Rezoning Transportation Analysis

Petition Number: 2016-121

General Location Identifier: 17104315

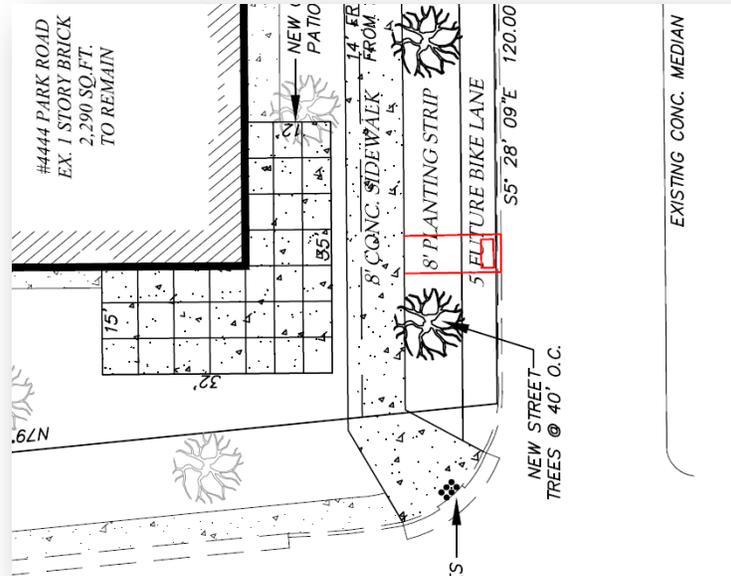
1. The petitioner should revise the site plan to show an accessible ramp in the general location as shown below (exact location to be determined during permitting phase) to align with pedestrian refuge island required of Rezoning Petition# 2015-120.
